# MONITORING YEAR 3 ANNUAL REPORT

## HENRY FORK MITIGATION SITE

Catawba County, NC  
DEQ Contract No. 005782  
DMS Project No. 96306

RE: **Response to MY3 Draft Report Comments  
Henry Fork Mitigation Project**  
DMS Project # 96306  
Contract Number 005782  
RFP Number 16-005298  
Catawba River Basin – CU# 03050103 Expanded Service Area  
Catawba County, North Carolina

Monitoring Year 3 - 2018

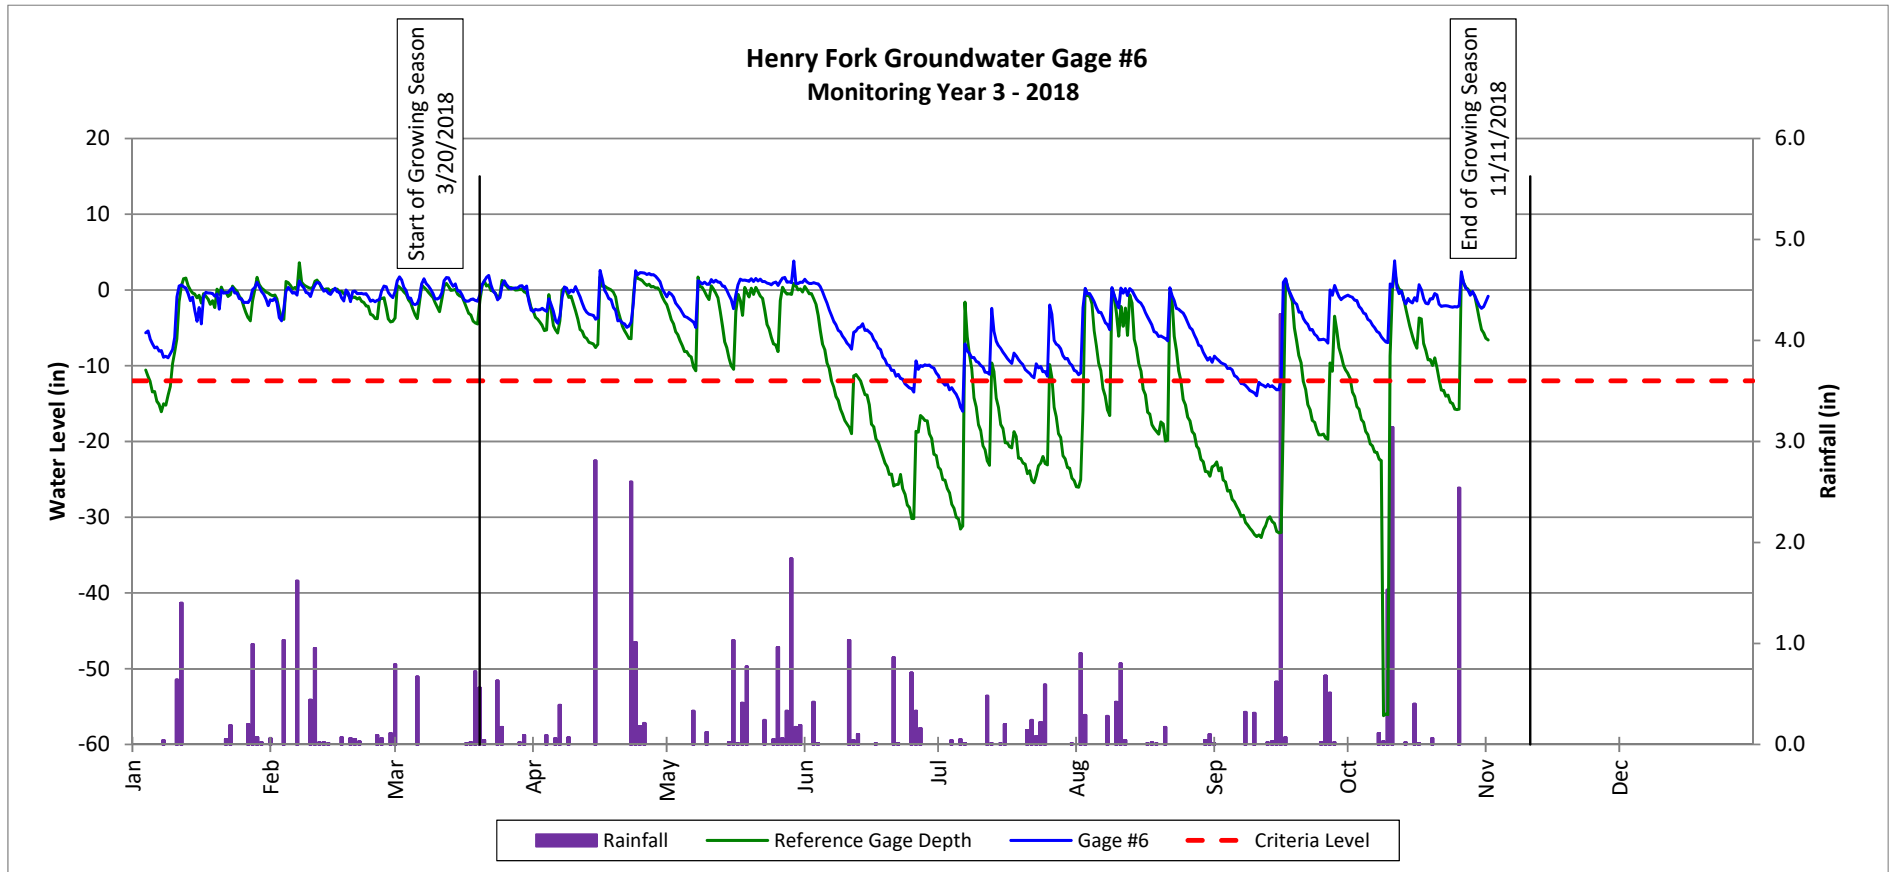
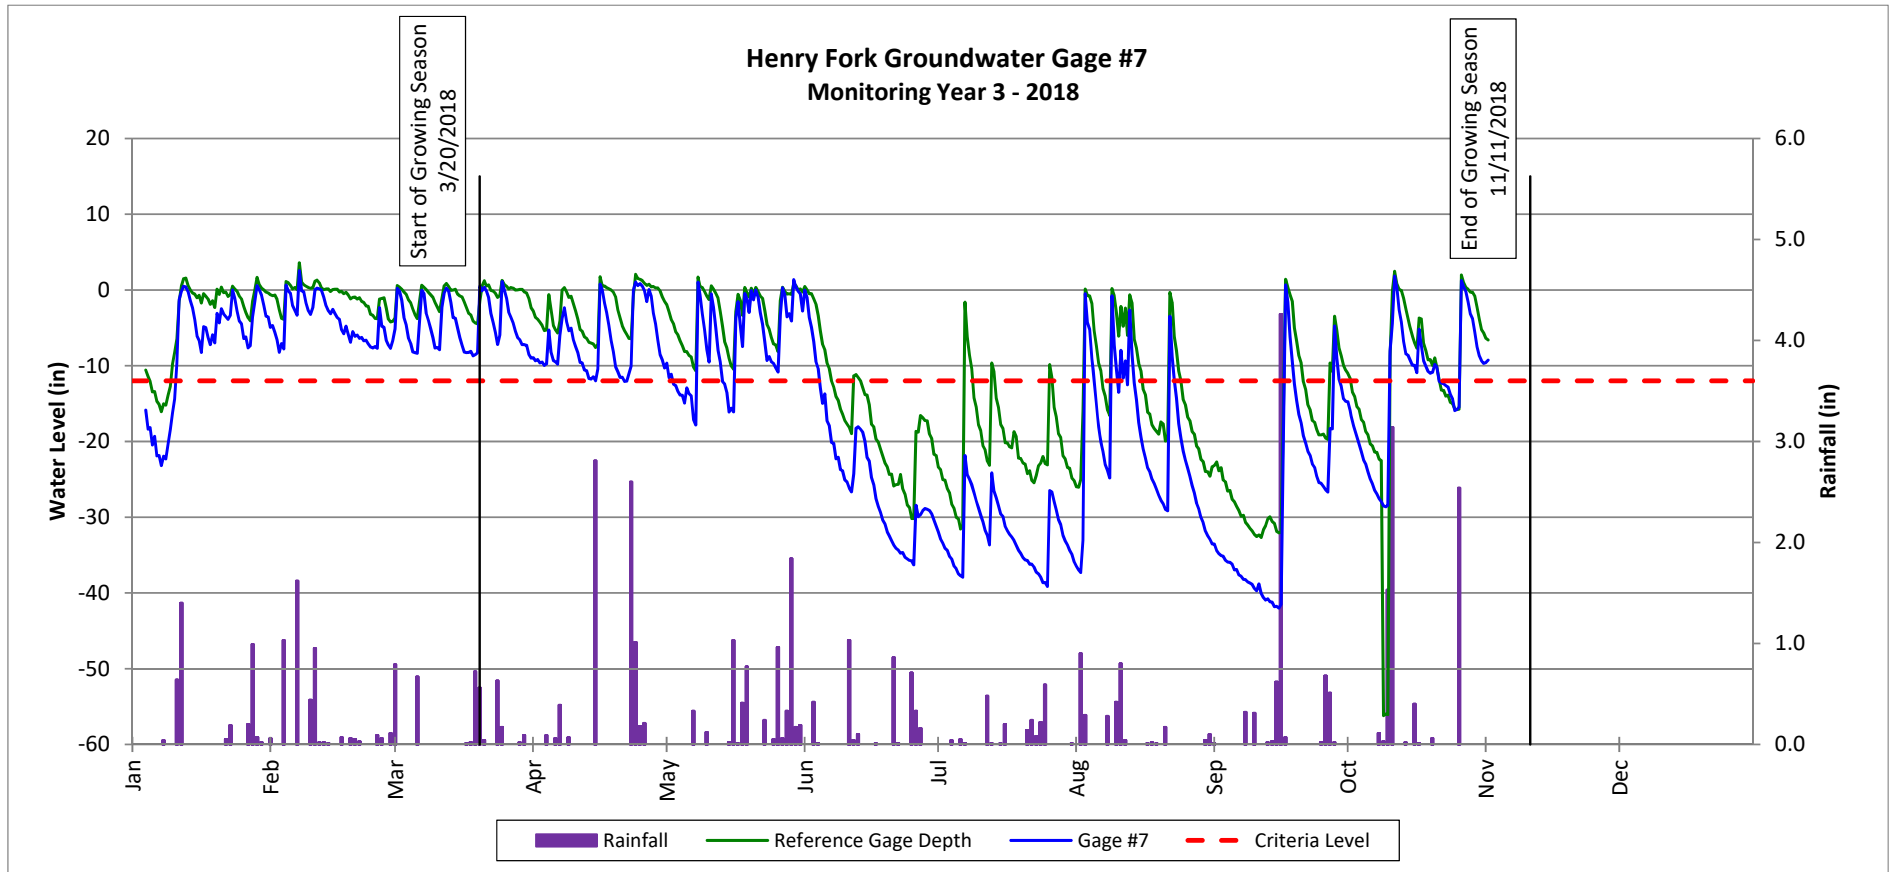
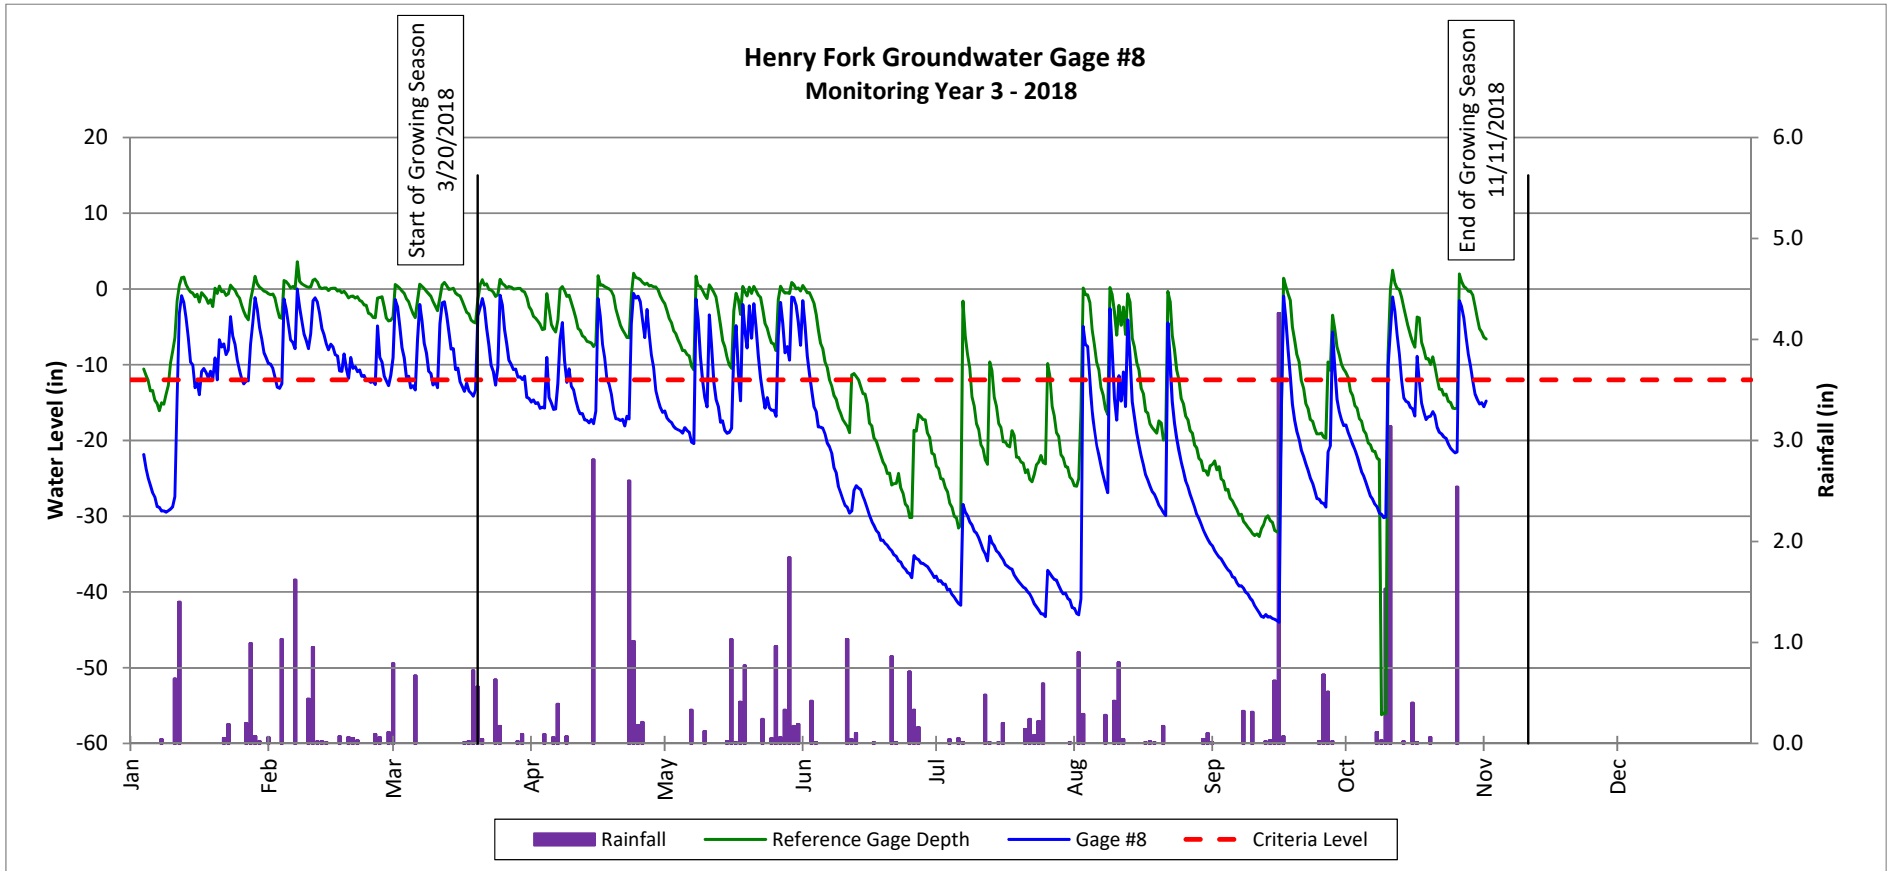
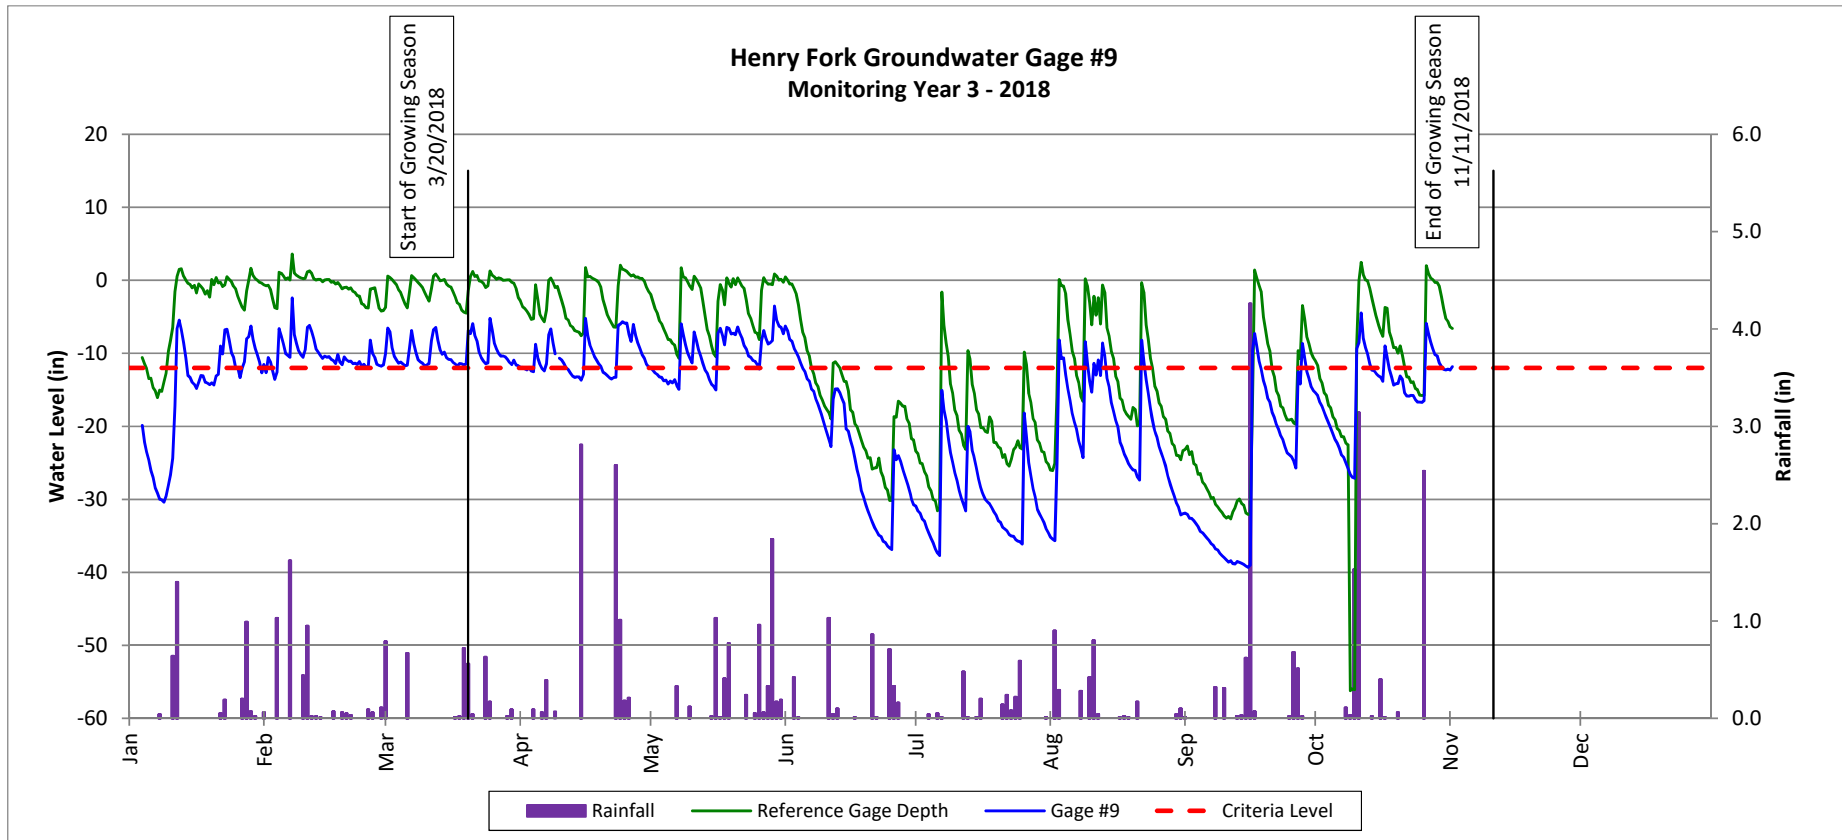
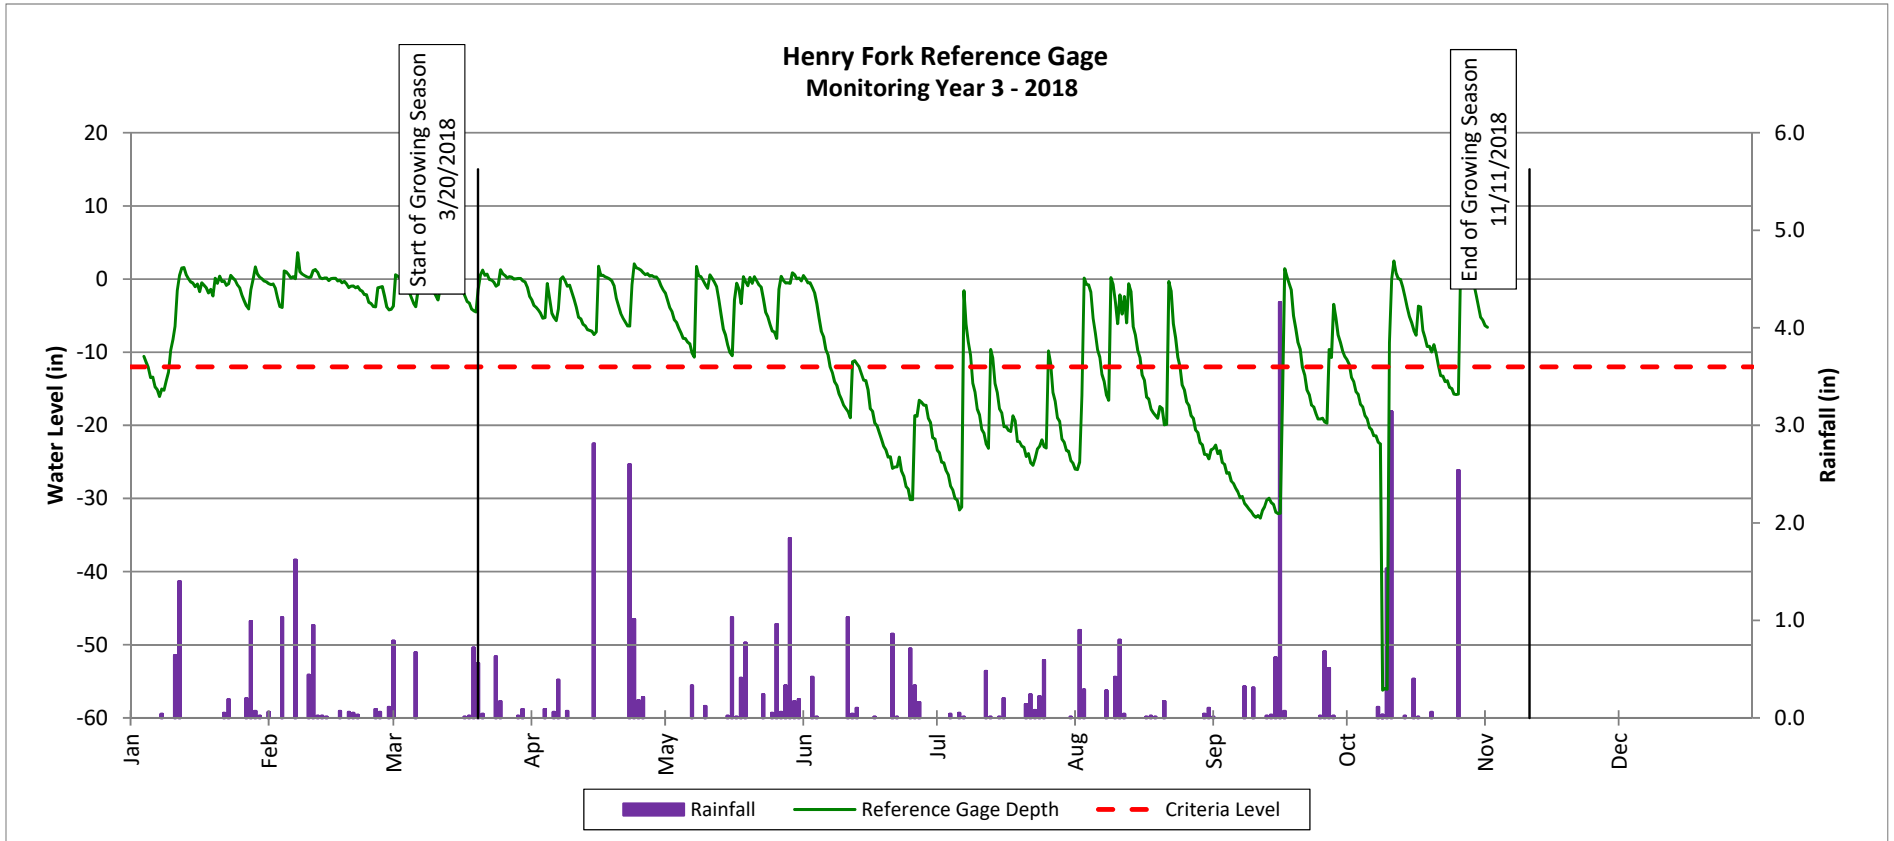
**DMS comment; Groundwater Gage 5 Plot: The report indicates that Wildlands believes Gage 5 may be malfunctioning. Please add a note to graph acknowledging that the data may be inaccurate, and the gage will be replaced.**

*Wildlands response; Wildlands has updated the groundwater gage 5 plot by adding a notation that the probe may be malfunctioning along with the probability that the data may be inaccurate and will be replaced.*
